# Determination 2025/032

**Regarding the proposed refusal to grant a building consent amendment for the recladding of a relocated dwelling**

**89A Fairclough Road, Beach Haven, Auckland**

**Figure 2: the jamb detail as shown in the plans.**

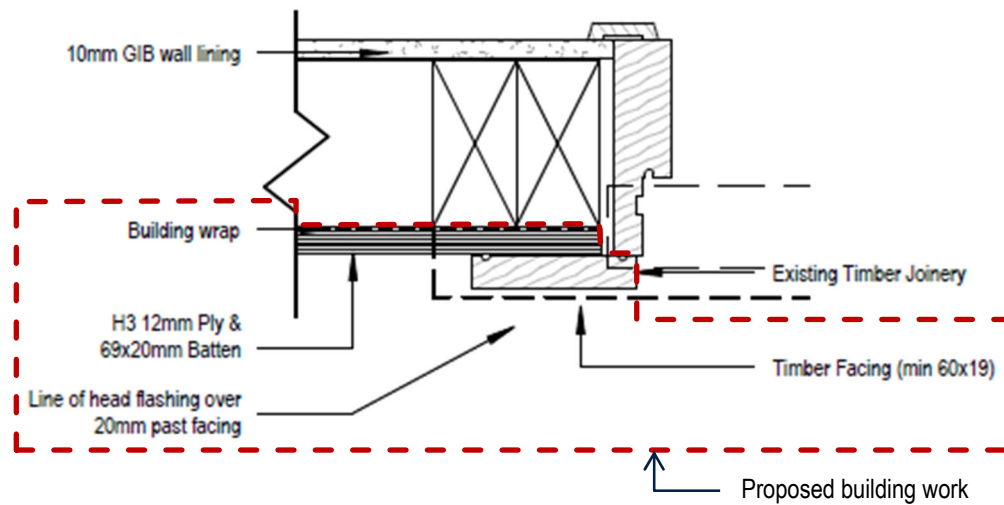
- 2.6. The proposed jamb and sill details for the existing windows are detailed in the plans for the amendment as follows:
  - 2.6.1. The jamb detail (figure 2) shows the existing timber wall framing, with double studs forming the side of the window opening. The existing timber window jamb is shown abutting the studs. The proposed building work includes new building wrap and plywood and batten cladding fixed directly to the existing framing. The building wrap is not shown dressed into the window opening (because of the retained jamb). A new 60mm x 19mm timber batten with weather grooves to the rear is to cover the junction where the new building wrap and plywood and batten cladding abuts the existing window jamb.

Please provide supporting evidence for means of compliance for timber joinery in direct fixed [proposed new cladding] system with no sill tray flashings and no jamb battens. (Please note that as the [proposed new cladding] system is new and joineries are to be reinstalled, compliance with clause E2 will need to be established.

- 3.2.1. The authority accepts the timber joinery windows are existing and that they “can be assessed against s112”. However, their concern is with preventing moisture getting into the area between the existing timber windows and the new building work and, if it does so, how that moisture will be managed.

- 3.2.2. The non-compliance of jamb and sill junctions could lead to moisture ingress which affects the new building work, being building wrap and the cladding, resulting in the new work not complying with the Building Code.

- 4.10. The proposed building work and the jamb and sill junctions are comparable to the previous cladding arrangement, which consisted of a direct-fixed sheet cladding with timber battens covering the junction between the cladding and existing timber windows. While I have not been provided evidence about the performance of the existing jamb and sill junctions, this detail is comparable to jamb and sill junctions with proven use over for decades in dwellings similar to this one, being a single storey timber-framed dwelling in a low wind zone.

- 4.11. On this basis I am of the opinion the new building work will achieve compliance with E2.3.2 and E2.3.5 if constructed in accordance with the plans and specifications. This means that the test in section 49 has been met in relation to these details. Therefore, this is not a reason for which to refuse to grant the amendment.

- 5.1. In accordance with section 188 of the Building Act 2004, I determine that there were not grounds on which to propose to refuse to grant the amendment to the building consent in relation to the jamb and sill details as shown on the plans.

**Figure 3: the sill detail as shown in the plans.**

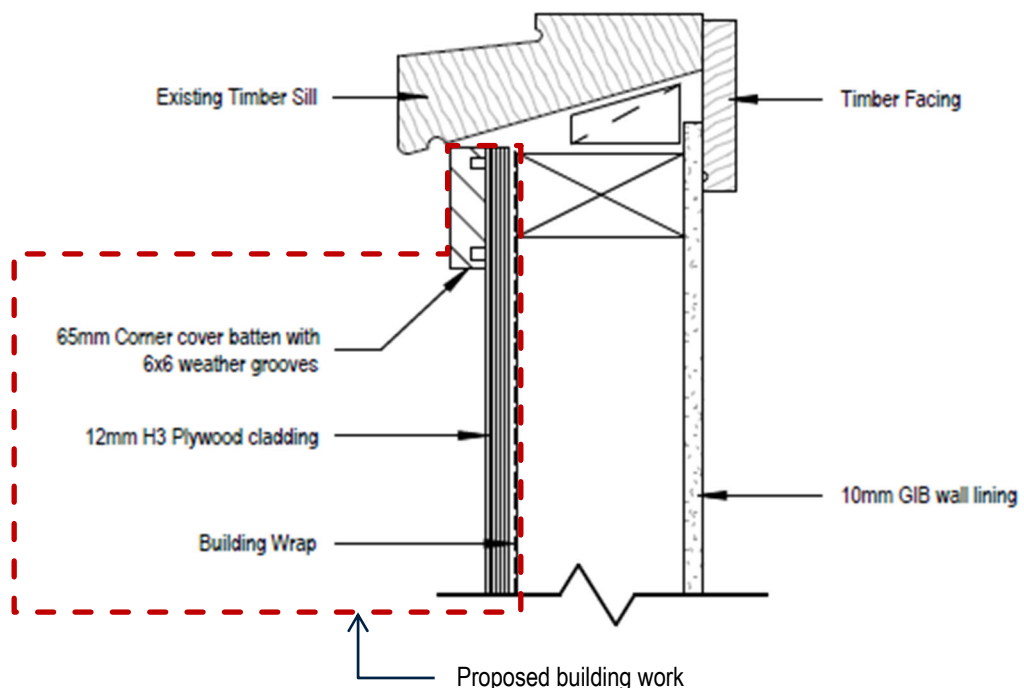
- 2.6.2. The sill detail (figure 3) shows the existing timber wall framing and timber packer supporting the sill of the existing timber window. The existing window sill is shown to have a weather groove to the underside of its outside edge. As with the jamb detail, the proposed building work includes building wrap and plywood and batten cladding fixed directly the existing wall framing. A new 65mm wide timber batten with weather grooves to the rear is fixed to the face of the plywood cladding, directly underneath the existing window sill.

- 3.2.3. If it is found that the current framing around the existing windows opening is not decayed as a result of the lack of the sill tray, and therefore is able to support the new cladding, the authority would accept the lack of a sill tray would not negatively impact compliance of the new building work.
